**REQUEST FOR EXCEPTION TO
RAPID CITY DESIGN STANDARD / CRITERIA / REGULATIONS**

PROJECT Proposed Lot 1 of Block 1 of Shortcut Subdivision

DESCRIPTION OF REQUEST: Exception request for stipulations in the March 5, 2015 Staff Report (No. 15PL015 - Preliminary Subdivision Plan)

Re: Request for Exception to not install a parallel water main along East Anamosa Street and to not provide sidewalk construction plans
Proposed Lot 1 of Block 1, Shortcut Subdivision
NW $\frac{1}{4}$ S4, T1N, R8E, Rapid City, Pennington County, South Dakota

Figure 6.4
Water System
Capital Improvement Projects
Rapid City, SD

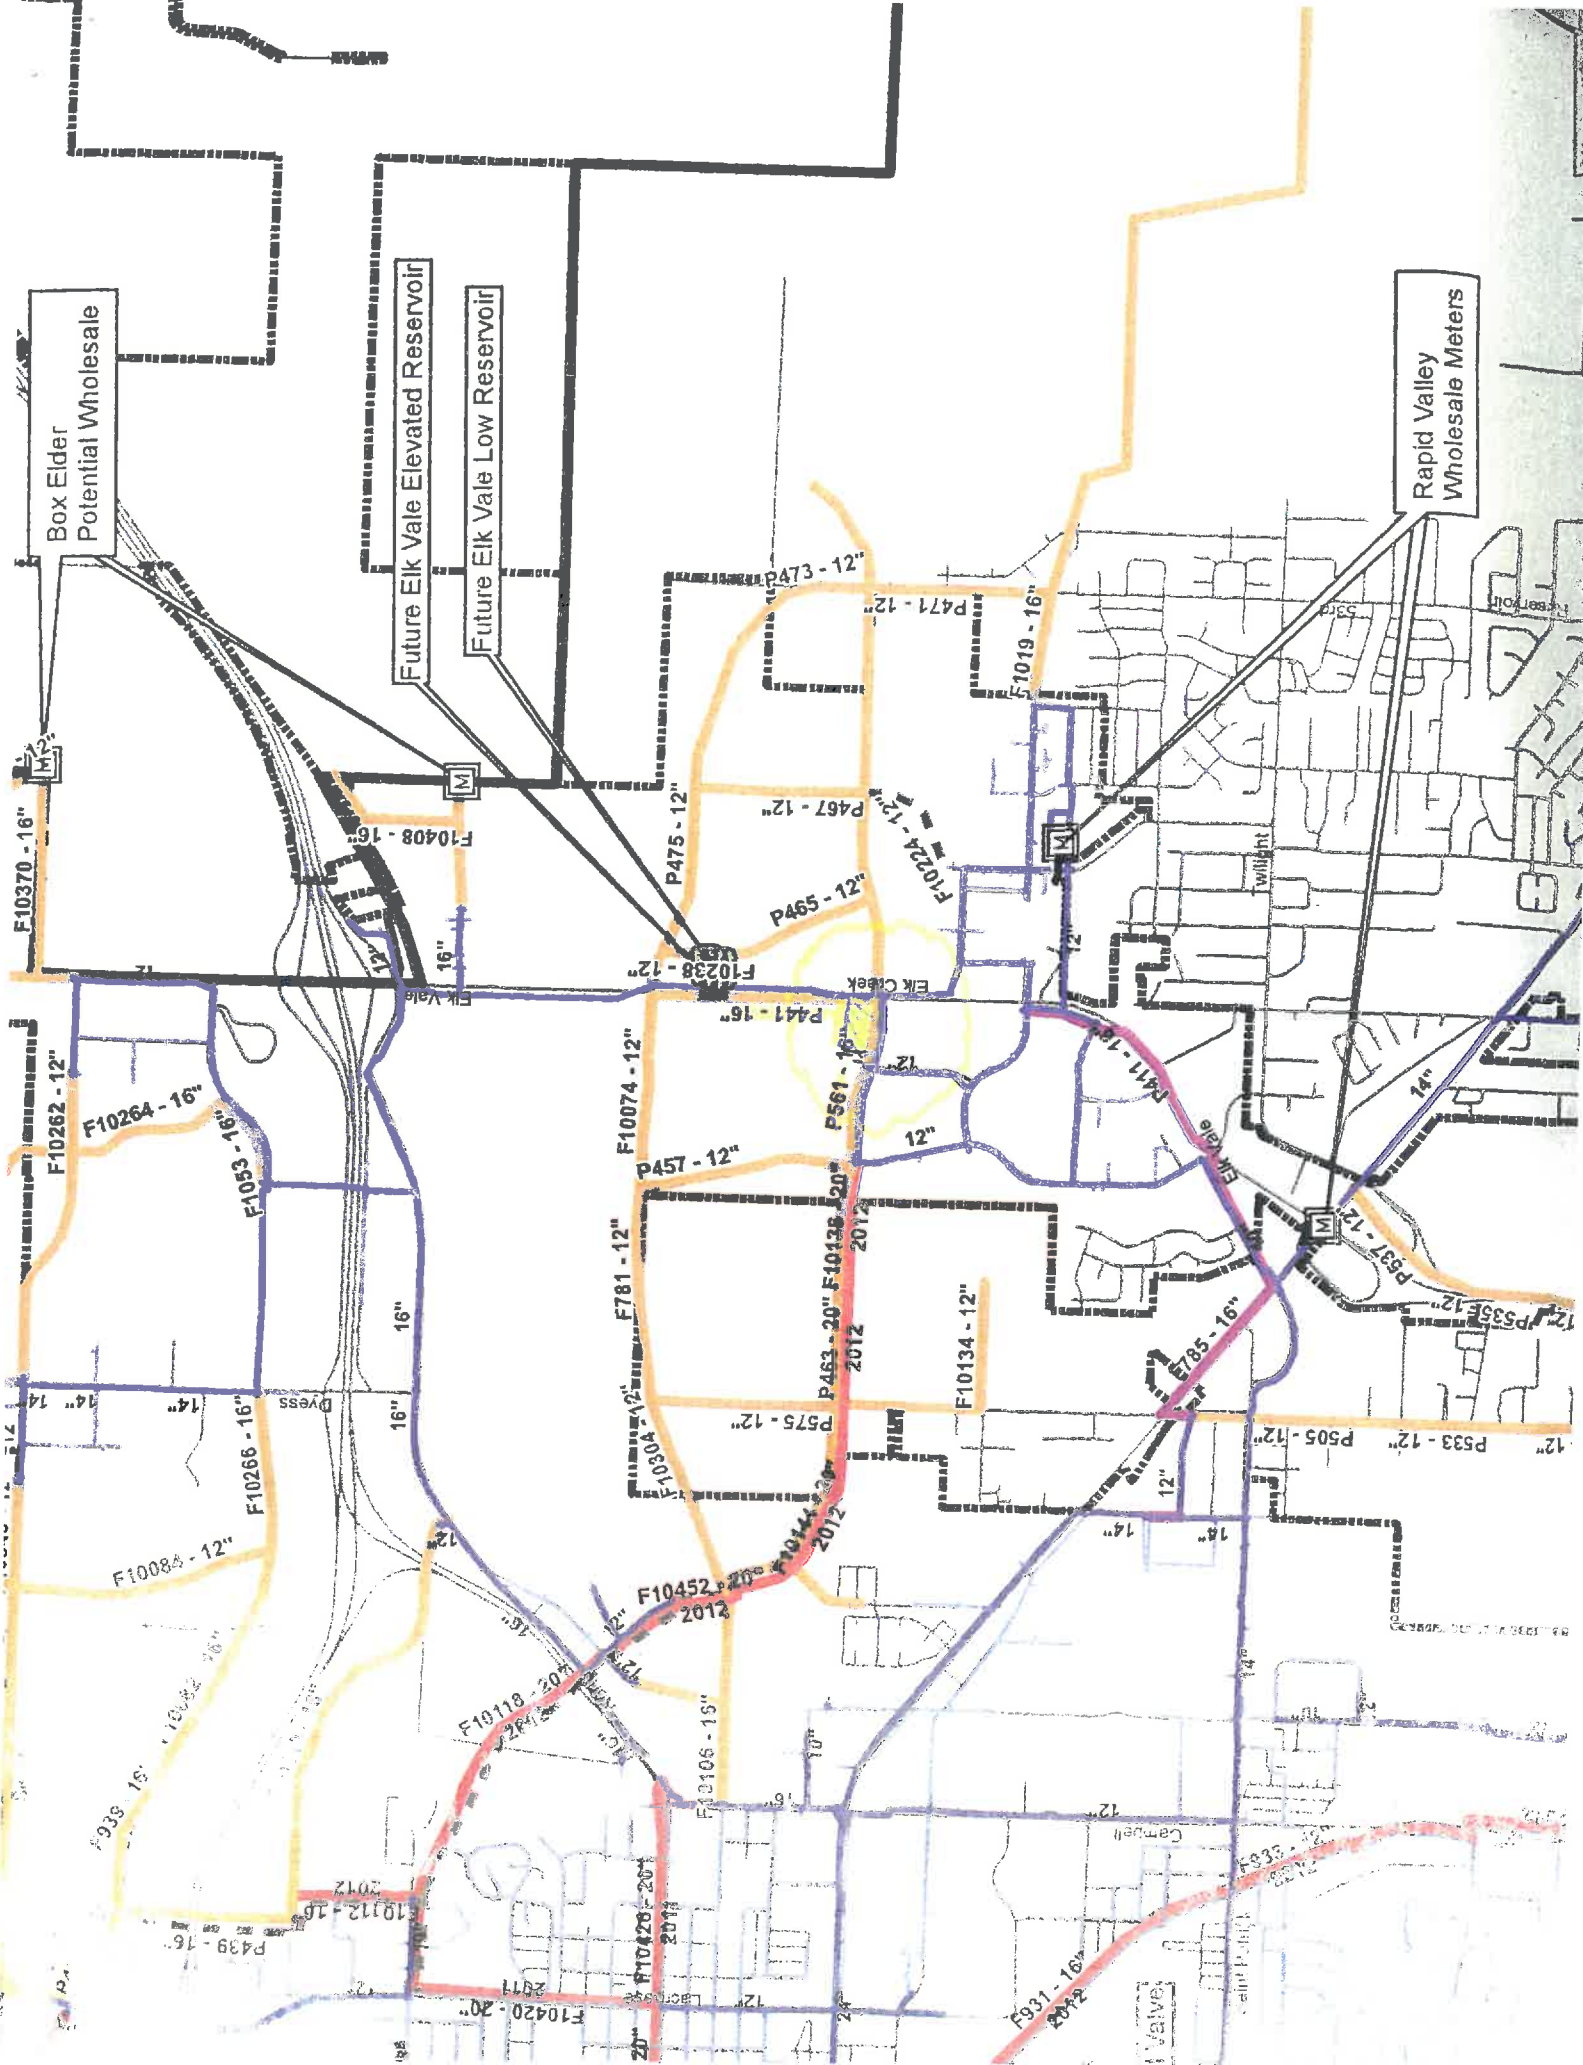
Based on more recent master planning and water modeling, the water main to be installed along the north side of E. Anamosa St. needs to be a 20" main, not 16" as previously identified. The costs of the oversized water main in excess of the base size required for the proposed lot would be eligible for reimbursement by the City. In accordance with the City's adopted utility plan, and IDCM criteria, a 20" water main is required to be installed with this subdivision platting project.

WATER UTILITY EXISTING AND CONCEPTUAL LAYOUT EAST

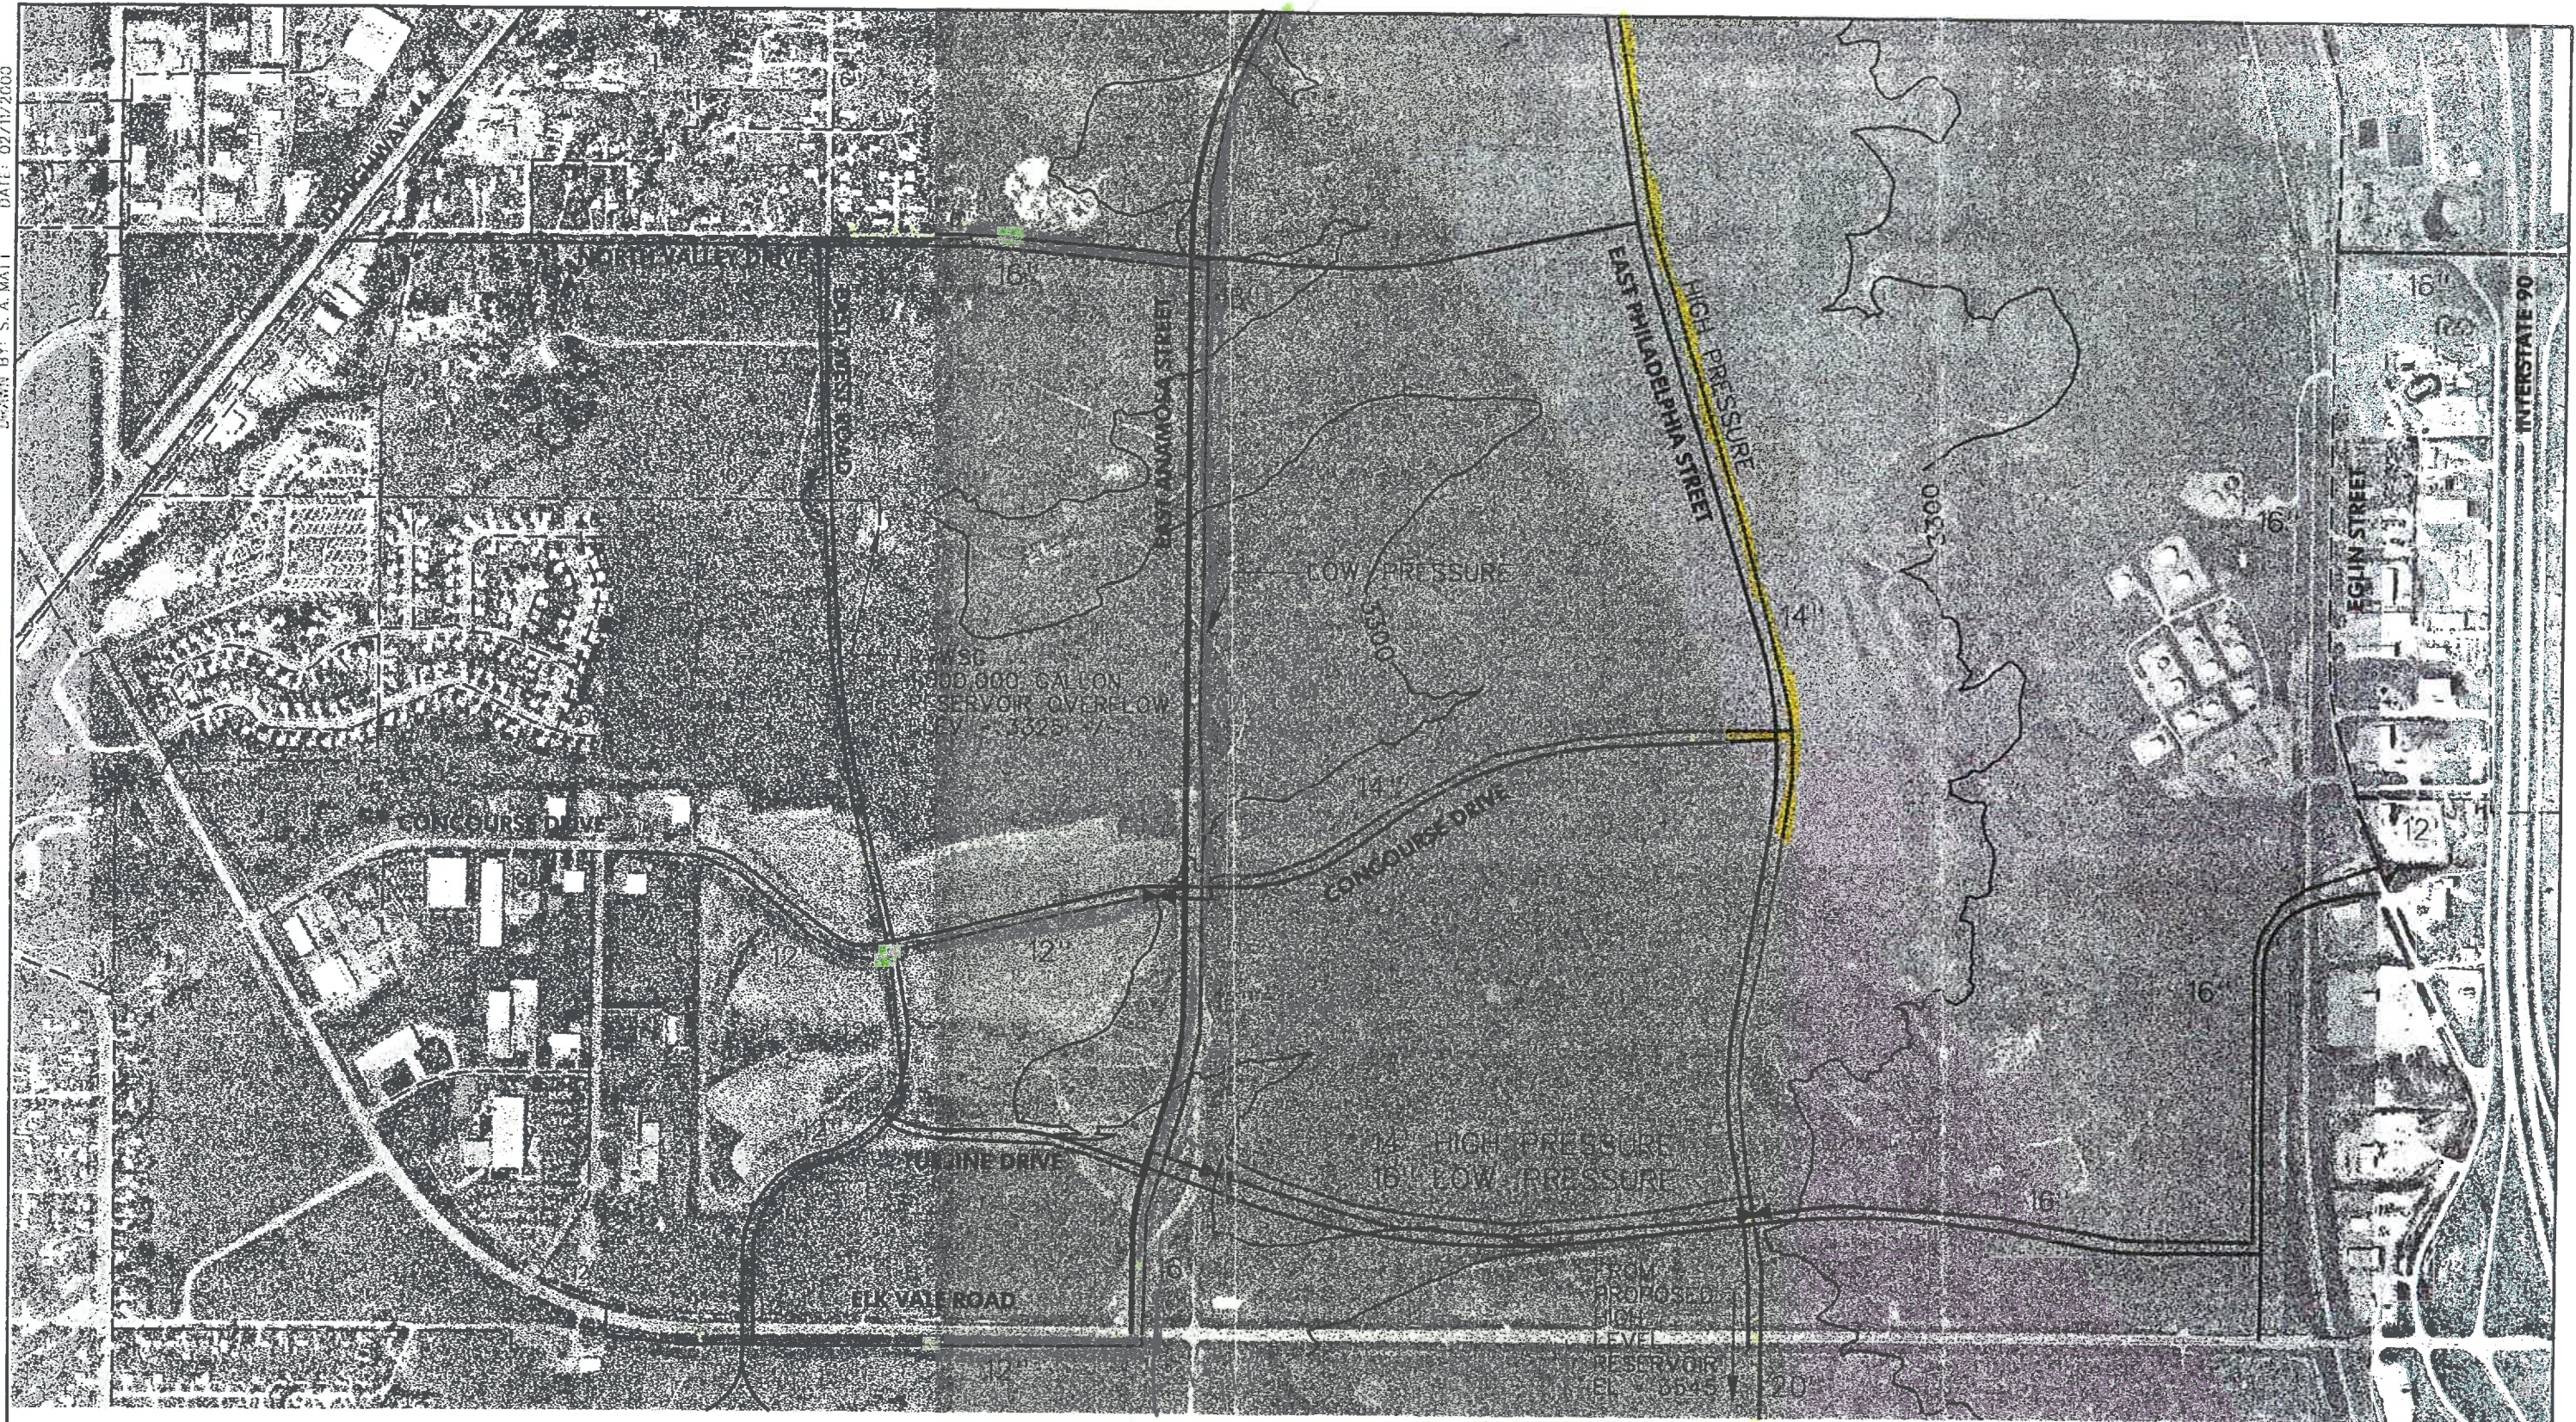
Handwritten notes:
 12" HP N.R.
 12" HP N.R.
